# Nyrstar Port Pirie Smelter Transformation Proposal Response Document

October 2013

Response Document

Figure 2: Comparison with the proposed Water Quality Policy based on a 25 m diffuser with six 0.12 m ports and high exit velocity. Dotted lines show the monthly comparison and the bold lines the weekly comparisons

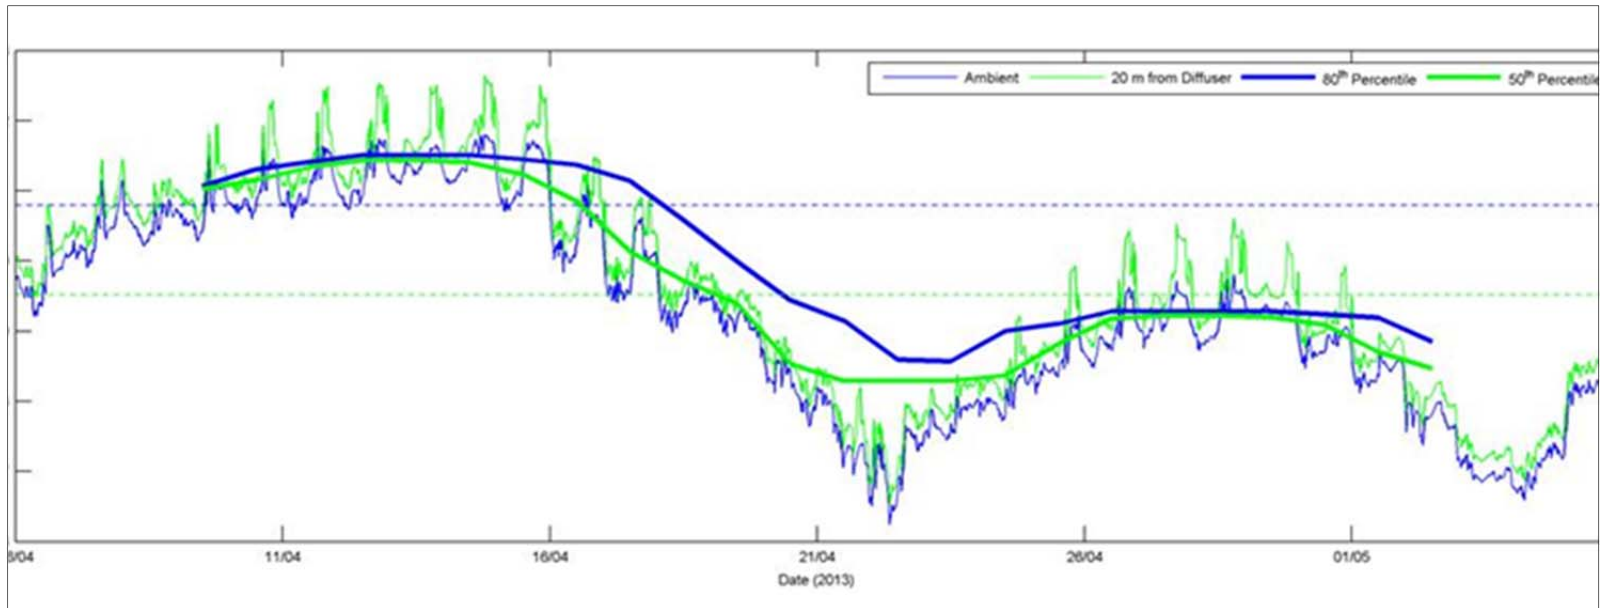
2. Further work is needed to optimise the diffuser design to provide a better understanding of the conservatism in the model predictions.
3. The flushing rate for the Port Pirie River may be limited. Further temporal far field modelling is therefore required to demonstrate that heat will not accumulate in the upper reaches of the Port Pirie River.

Compliance with the proposed guideline was also tested i.e. the 50th percentile of the temperature of the plume at 20 m from the diffuser is less than the 80th percentile of the ambient temperature. Using the 25 m diffuser with six 0.12 m ports and high exit velocity the diffuser was found to be compliant using both the monthly and weekly comparisons (**Figure 2**). However, it is noted that there is difficulty in maintaining compliance during spring tides when there is relatively little variation in temperature (see **Appendix B**).
